Town of Brookline

PLANNING BOARD

Subject: Construct a parking area in the front yard, convert portion of basement to one car garage with entrance in front; install staircase in the rear, and construct addition in the rear requiring relief for side and rear setbacks

Location: 29 Summit Avenue

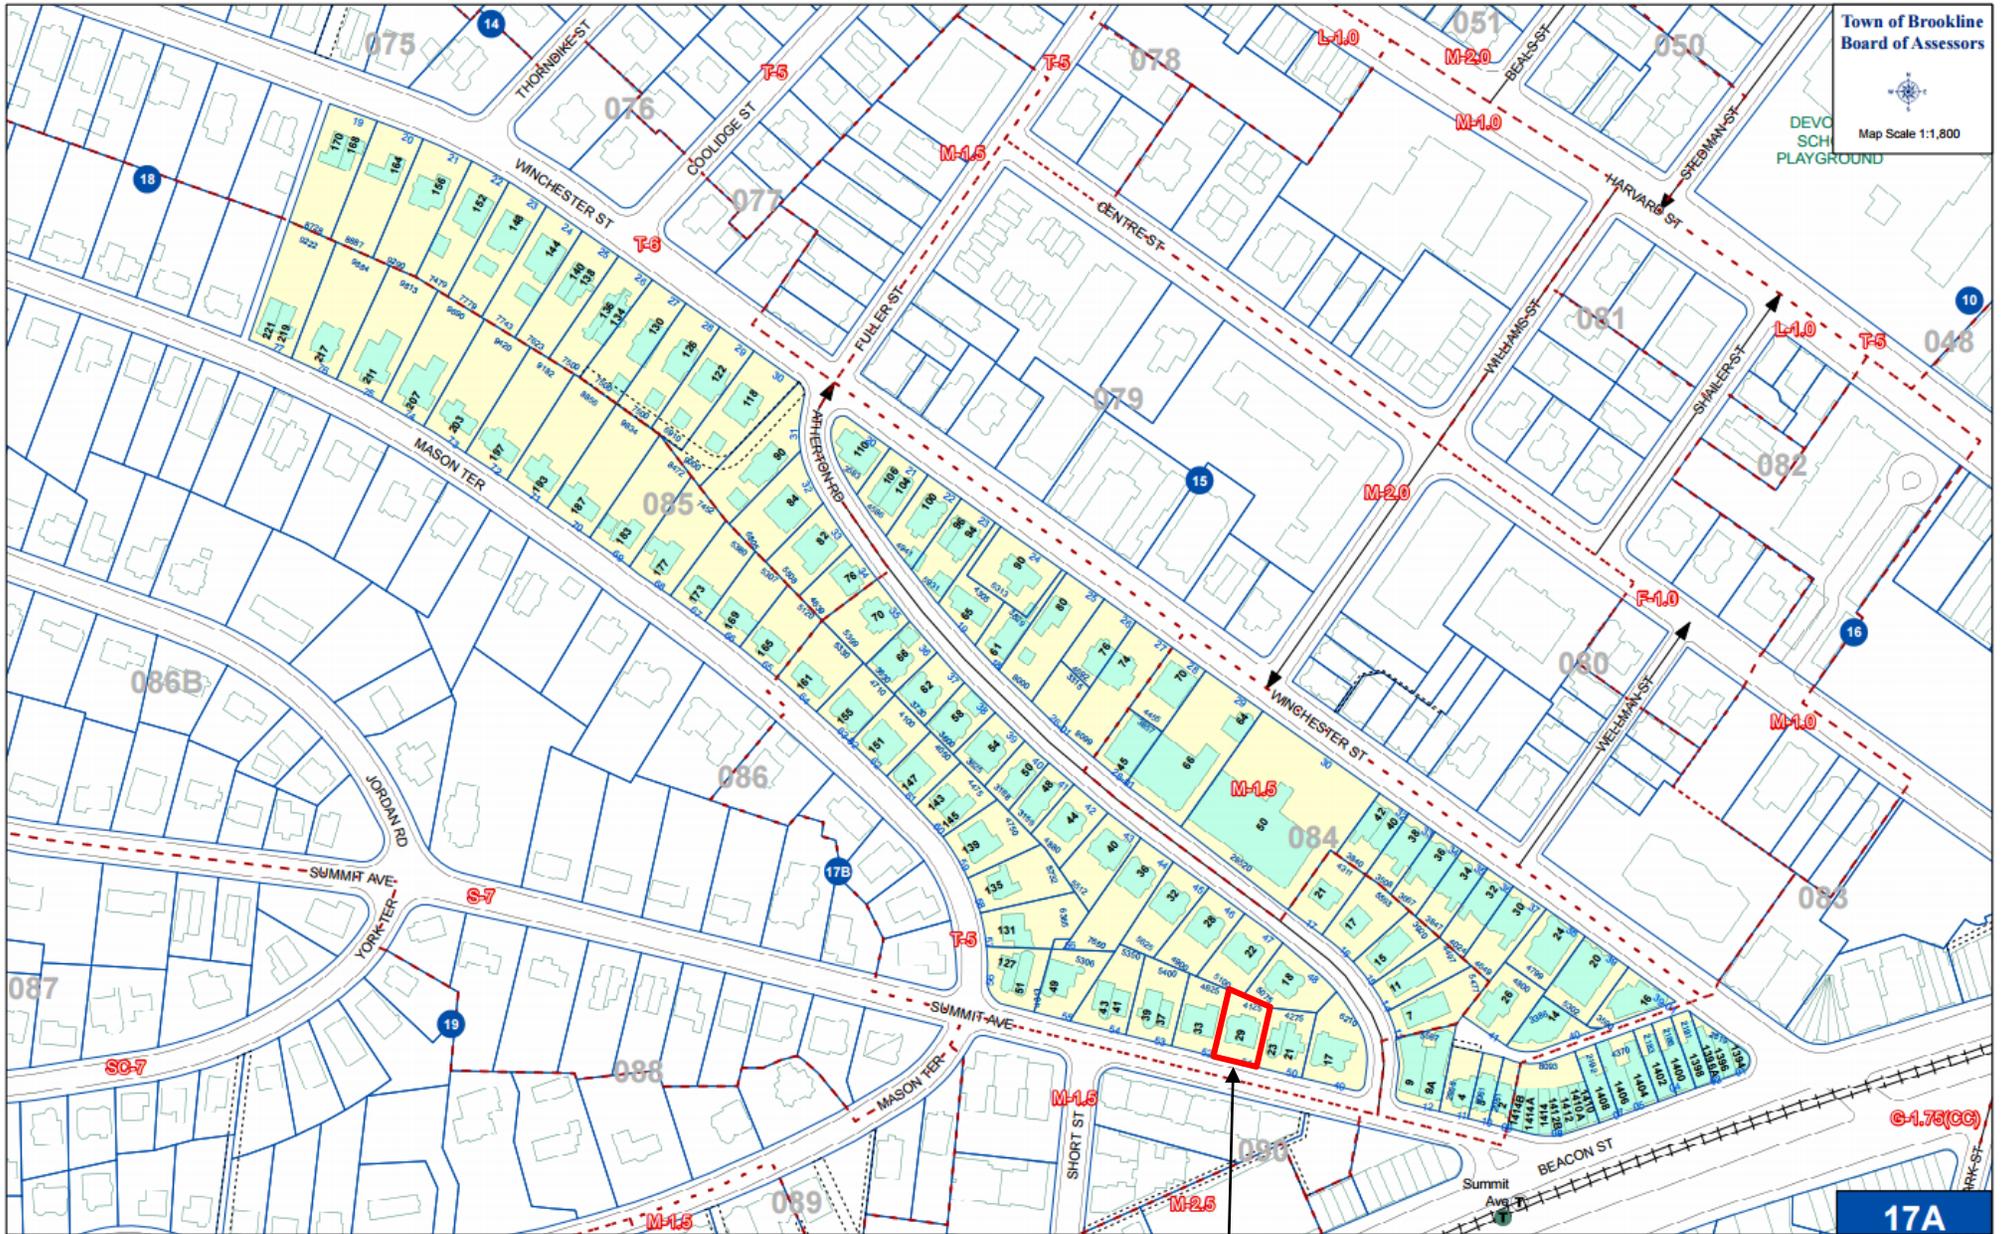
View of rear yard at 29 Summit. Rear property line and fence is at the right. Retaining wall is covered by excavated earth.
